Further Refinement to RLdc Masks

(Comments 169 and 170)

**IEEE 802.3dj Interim Meeting
Minneapolis**

RLcd11/RLdc22 Comments

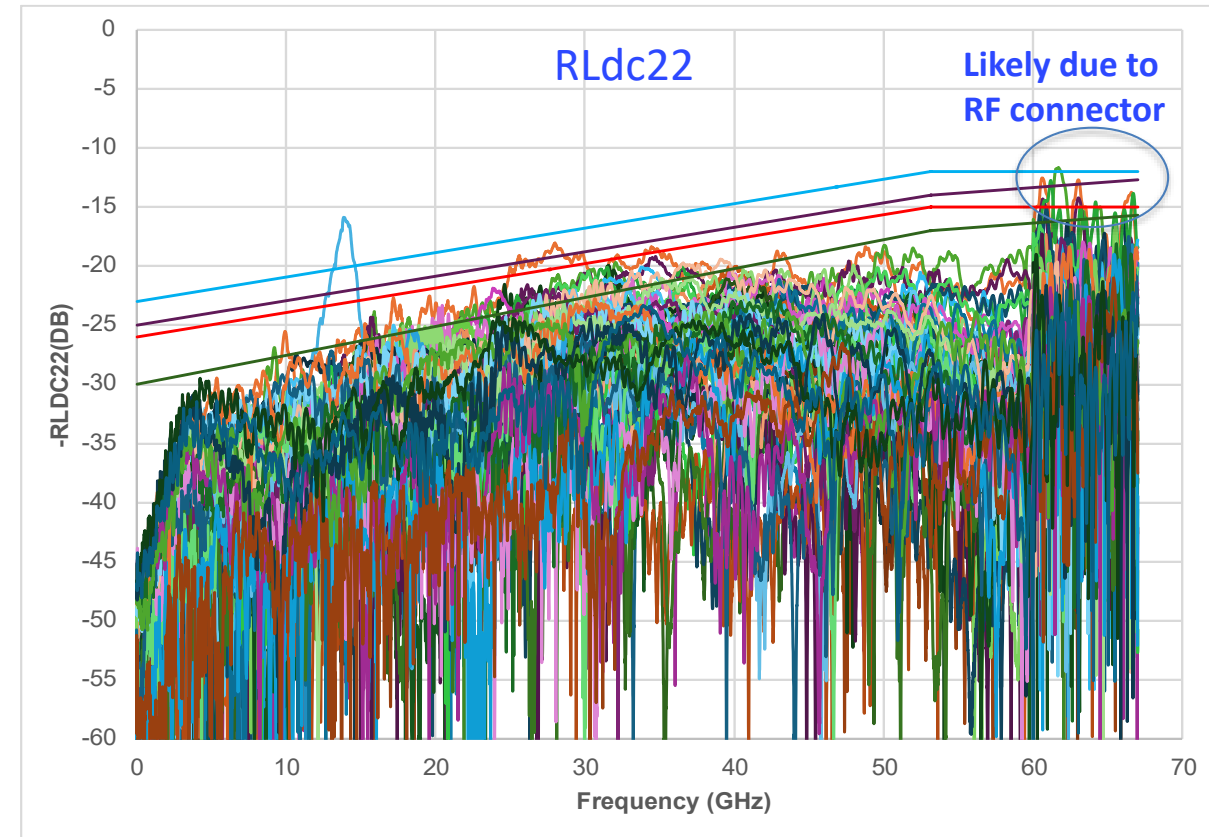
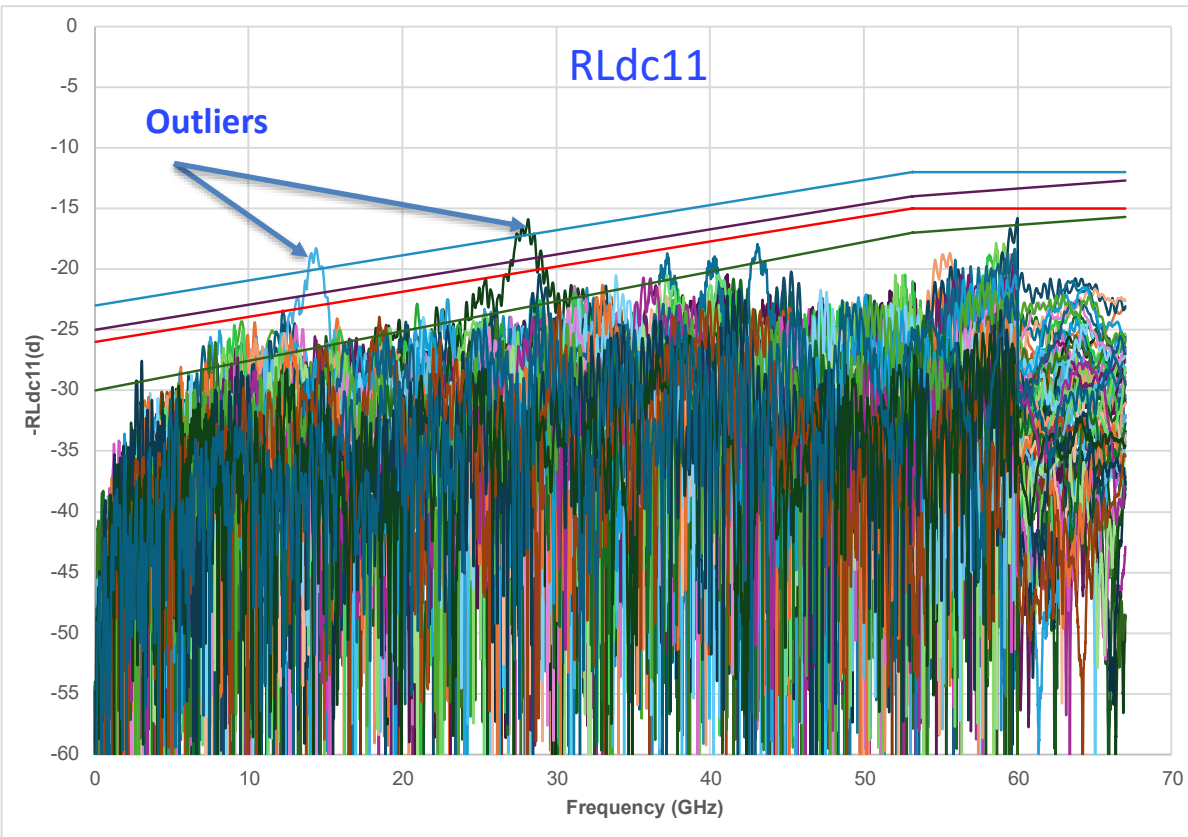
- ❑ **S-Parameters masks RLcd11/22 limit for both MTF and host output TP1a and module output TP4 were strengthen during D2.0 comment resolution and the limit was extended from 60 GHz to 67 GHz**
 - Another major change was changing $Z_0=92.5 \Omega$ which generally improves the RLcd11/22 by $\sim 5\text{dB}$
 - RLdc22 is slightly better than RLdc11 due to higher HCB loss but not enough to create separate mask limits
- ❑ **The changes made during D2.0 are in the right direction but the limits adopted are to strengthen for connectors under consideration**
 - Proposed RLdc11/22 for the MTF
 - $RLdc11 = RLdc22 = 26 - 22 \times \frac{f}{106.25}$ up to 53.125 GHz
= 15 dB from 53.125 GHz to 67 GHz
 - Proposed RLdc11/22 for the TP1a/TP2 and TP4a/TP4
 - $RLdc11 = RLdc22 = 23 - 22 \times \frac{f}{106.25}$ up to 53.125 GHz
= 12 dB from 53.125 GHz to 67 GHz

MTF RLdc11 and RLdc22 (100 Ω) for Information

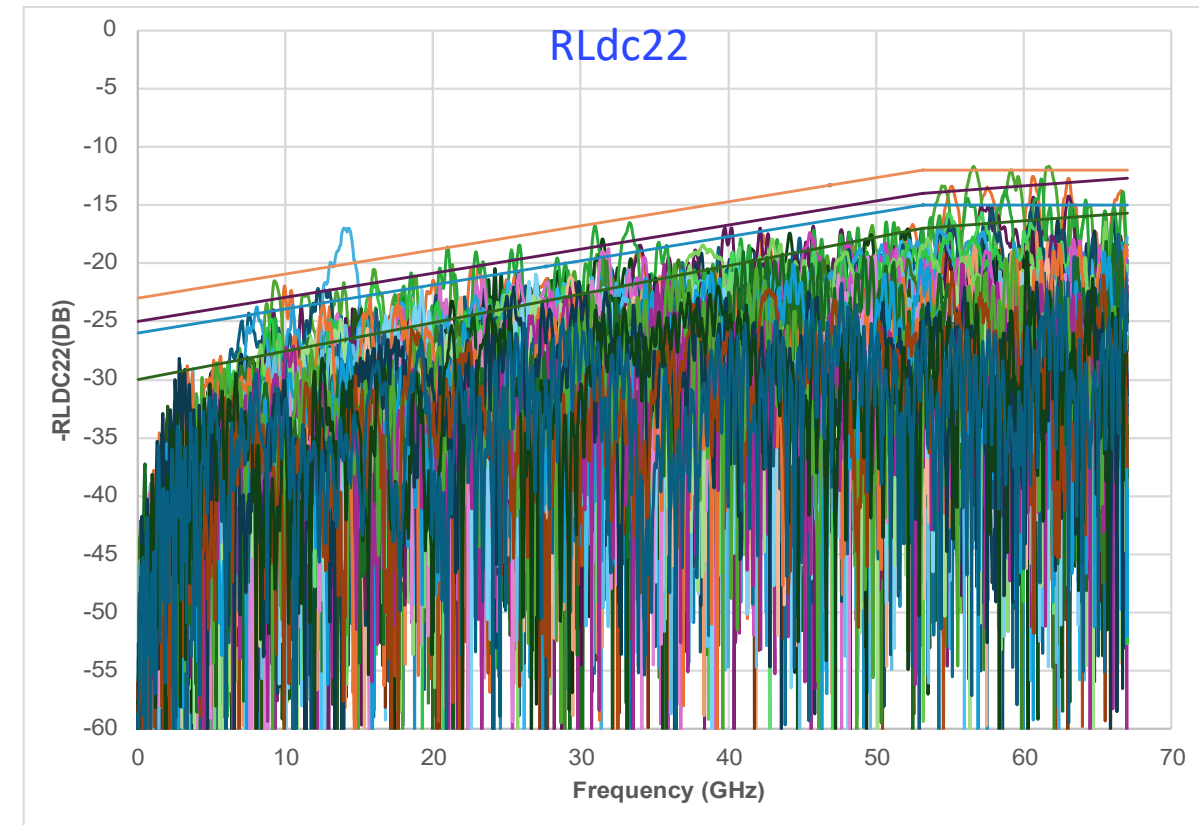
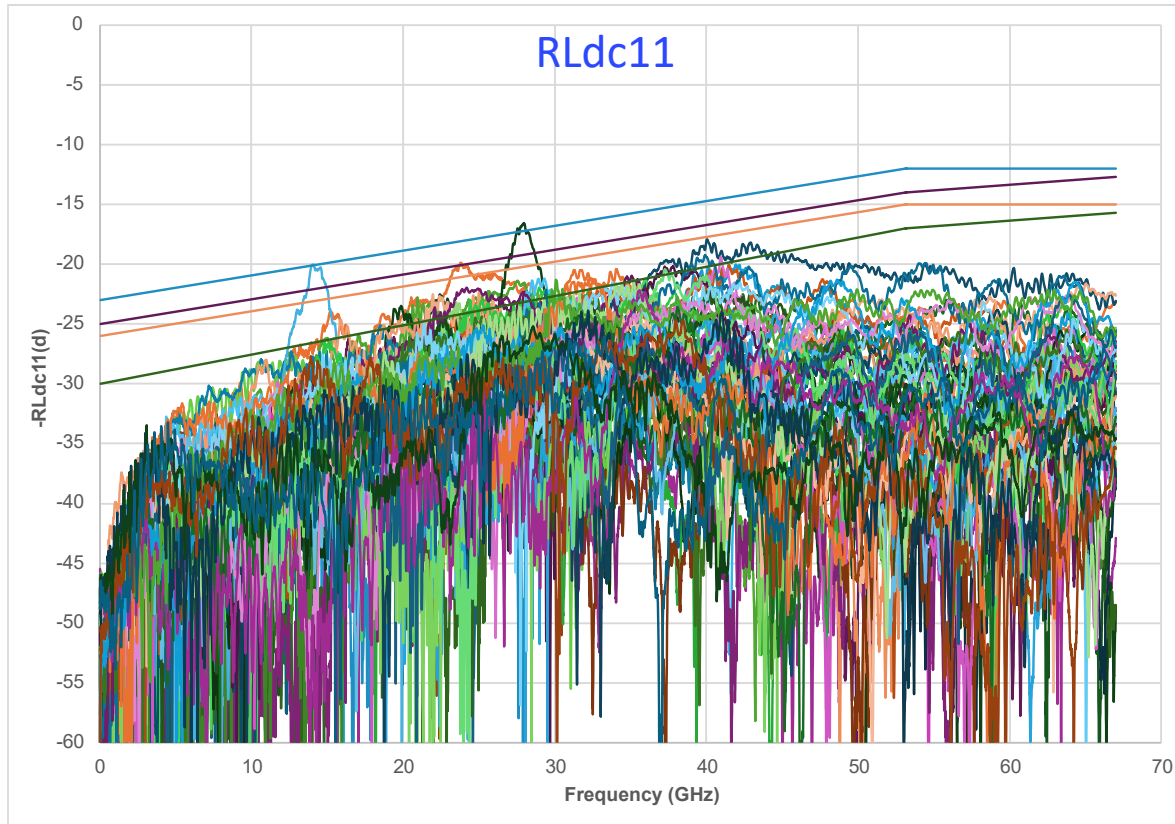
— RLdc11 is slightly better due to HCB higher loss than MCB loss

- Brown – current MTF limits, Black – current host/module limits
- Red – Proposed MTF limits, Blue – proposed host/module limits
